Baseline Text for Clause 55.X MDI Specification and Environmental Specifications

Terry Cobb
Systimax

- **A review of Clause 40.8 and 40.9: 1000BASE-T MDI specification and environmental specifications.**
- **Proposal for inclusion of these sub-clauses with changes to the 10GBASE-T draft.**

40.8.3.1 MDI return loss

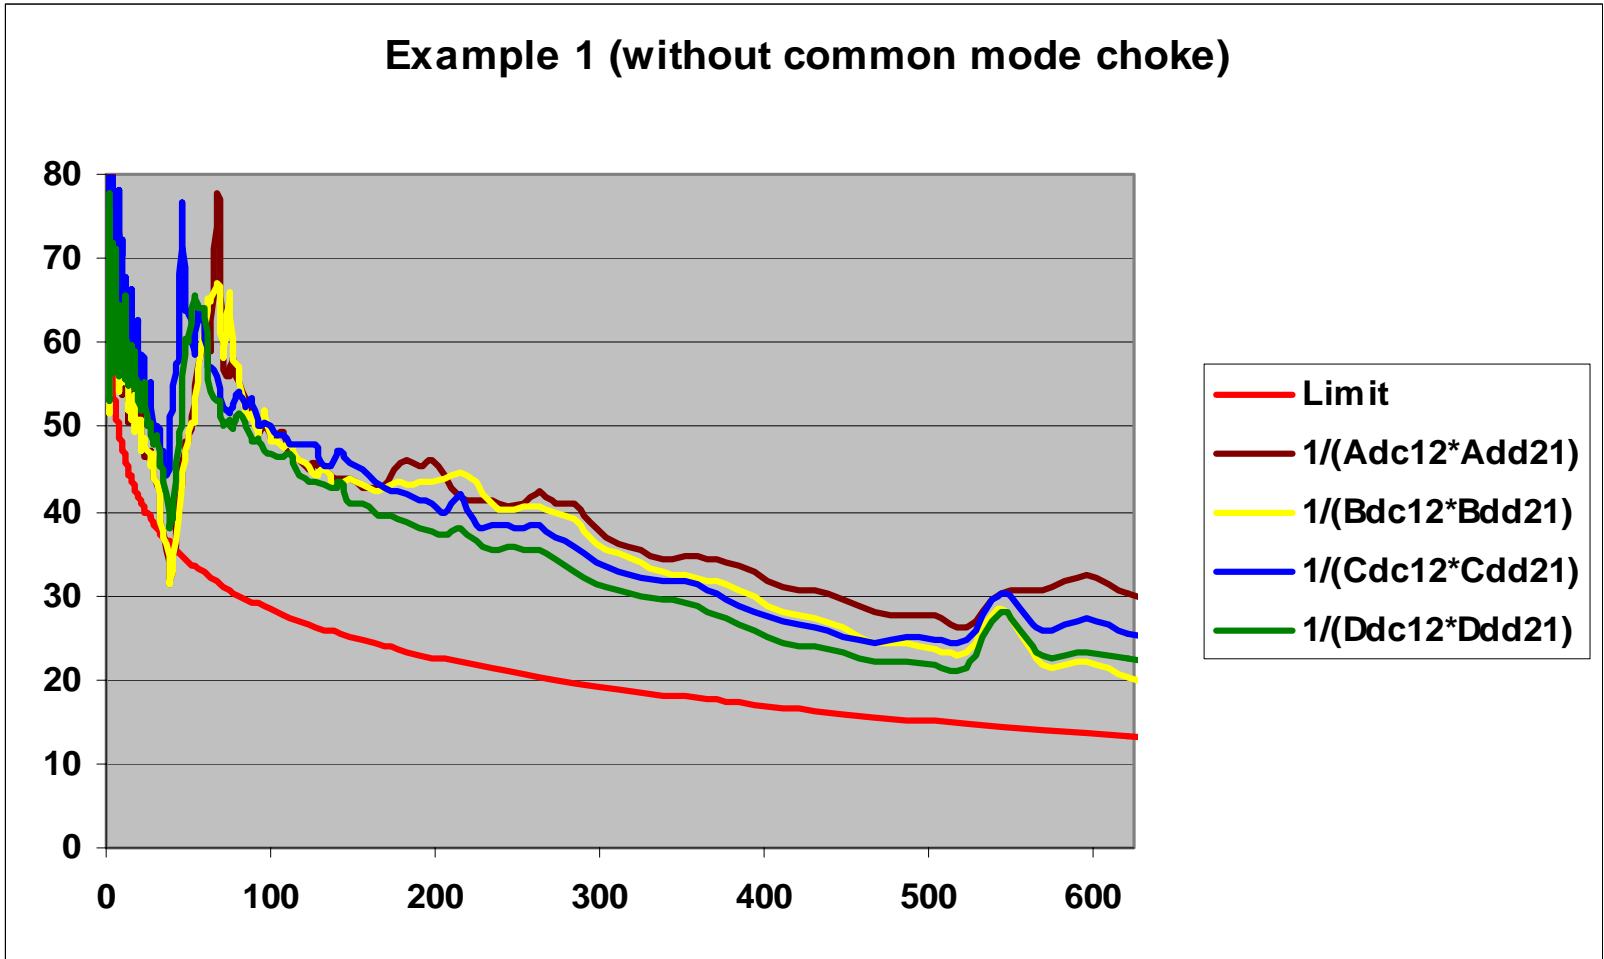
- **Defines the MDI return loss.**
 - **Change to the return loss as specified in motion by S. Gupta and approved at the May 2004 meeting.**

Comparison of Impedance balance to the Example Magnetics Models

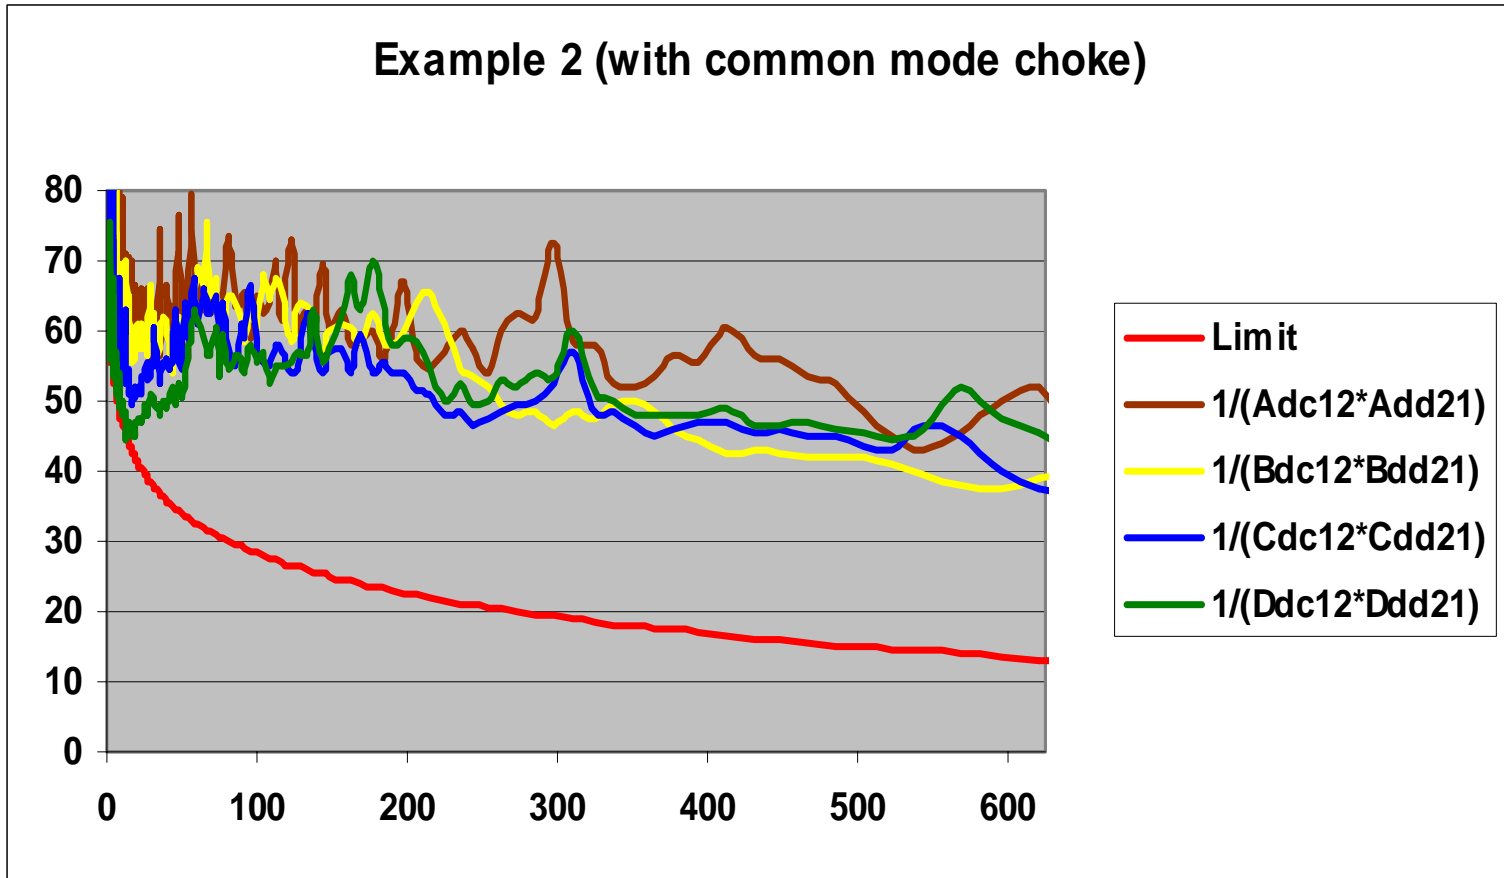
- **Defines the Impedance balance at the MDI connector.**
 - Defined as $34 - 19.2 \text{ LOG}(f/50)$
 - For reference compare limit to the channel model data on magnetics by calculating the Vcd11.

Comparing 1000BASE-T to 10GBASE-T

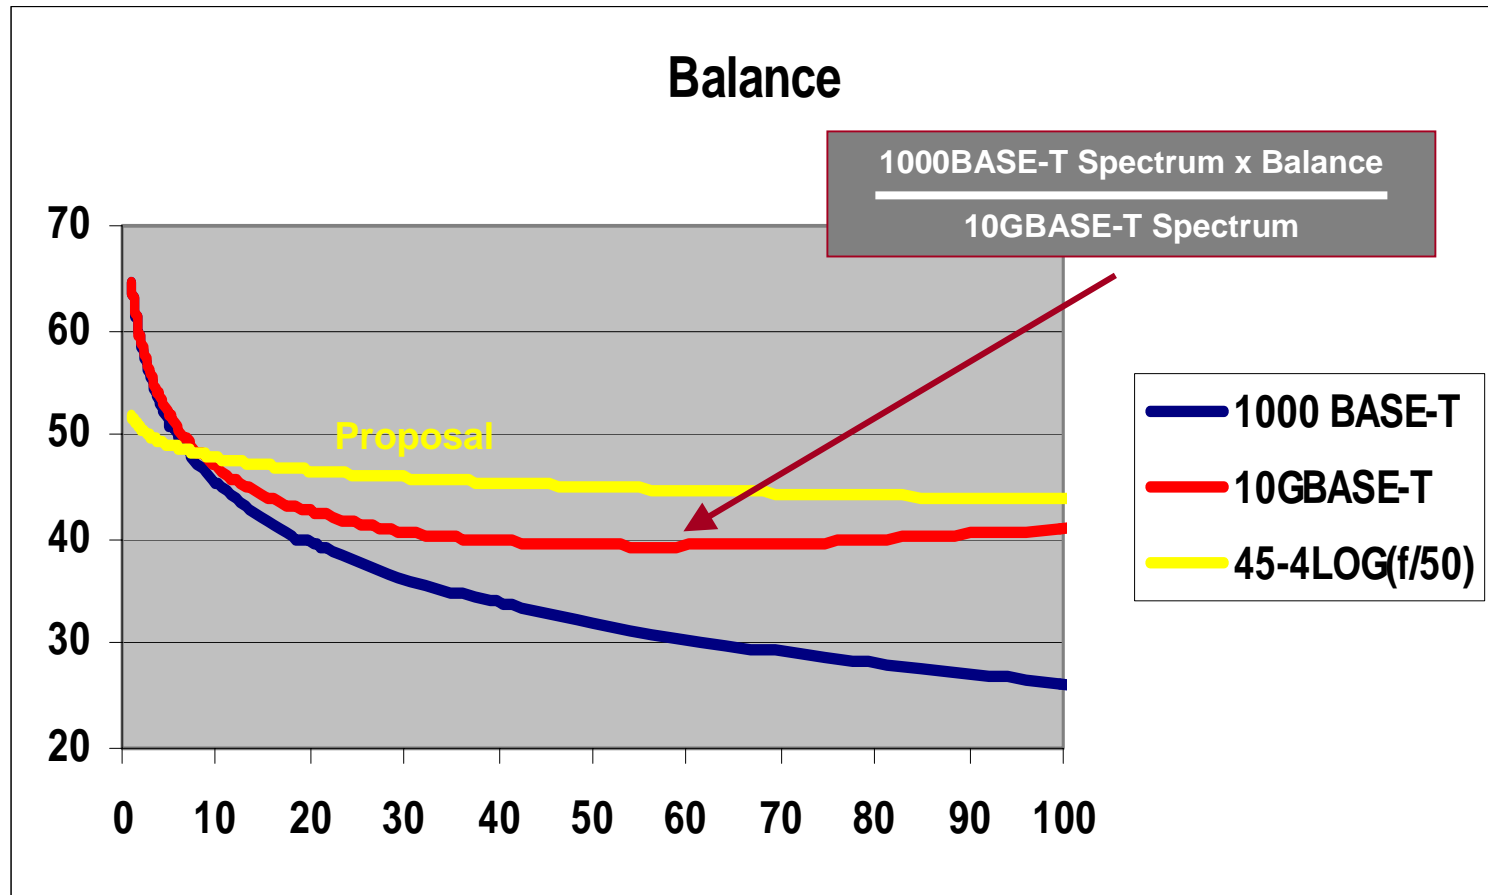
- **The common mode output for 1000BASE-T:**
 - Transmit Spectrum times the magnetics balance.
- **This should equal the same for 10GBASE-T**

- **Define the MDI Impedance balance 40.8.3.2**
 - $45 + 4 \text{ LOG } (f/50)$
- **And the common-mode output voltage 40.8.3.3**
 - maximum 15 mv peak to peak
- **Look at redefining measurement using a Network Analyzer set up.**

Comparing to the Magnetics Models

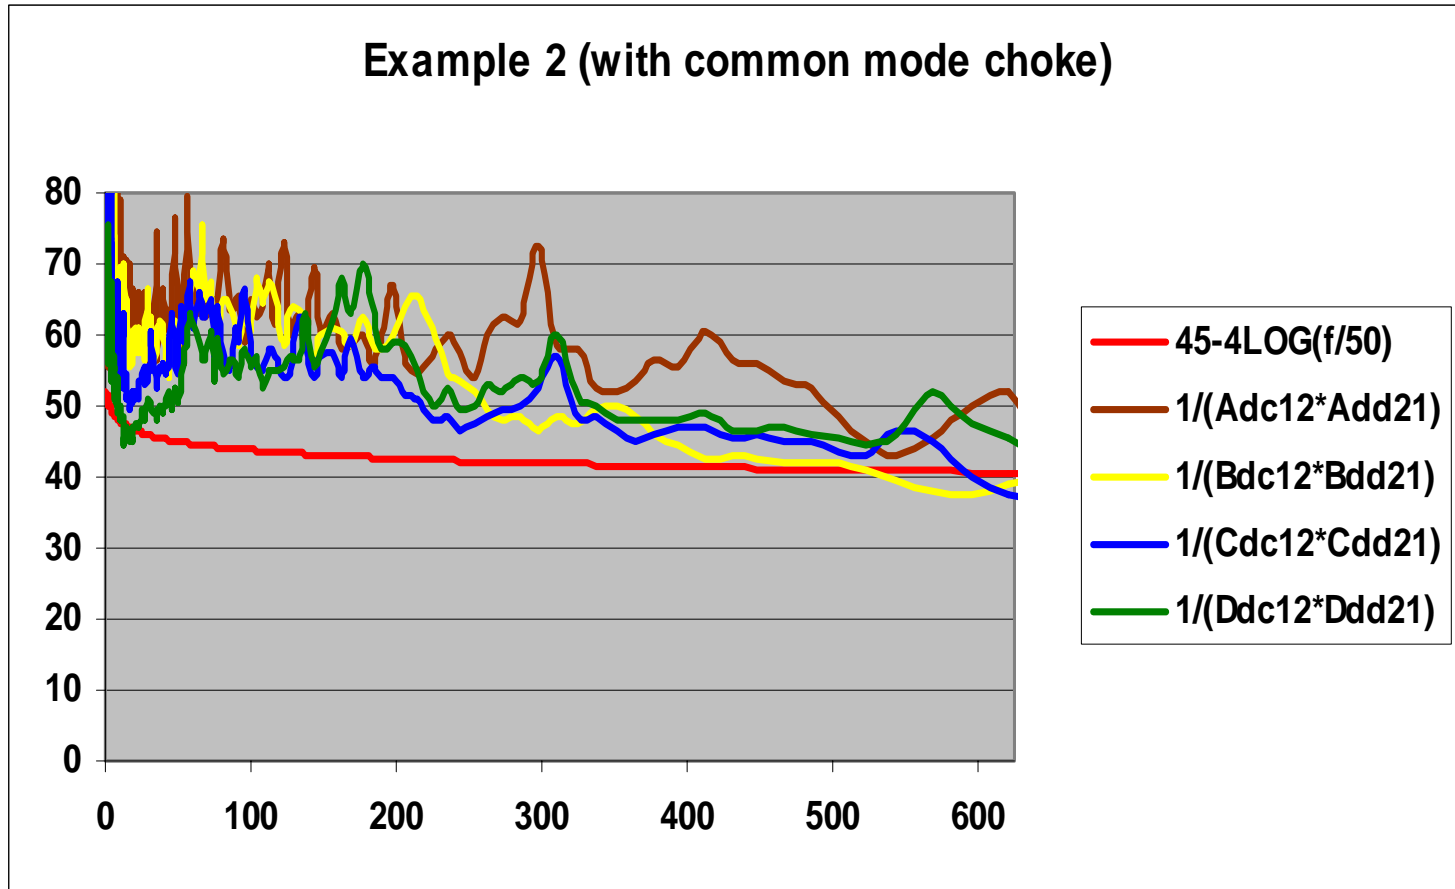
- **Significant improvement can be made by using the magnetics in example 2 with the common mode choke.**
- **The limit will depend more on what is required to meet the emissions objective or the common mode output due to magnetics balance.**
 - **Addressed in the following slides.**
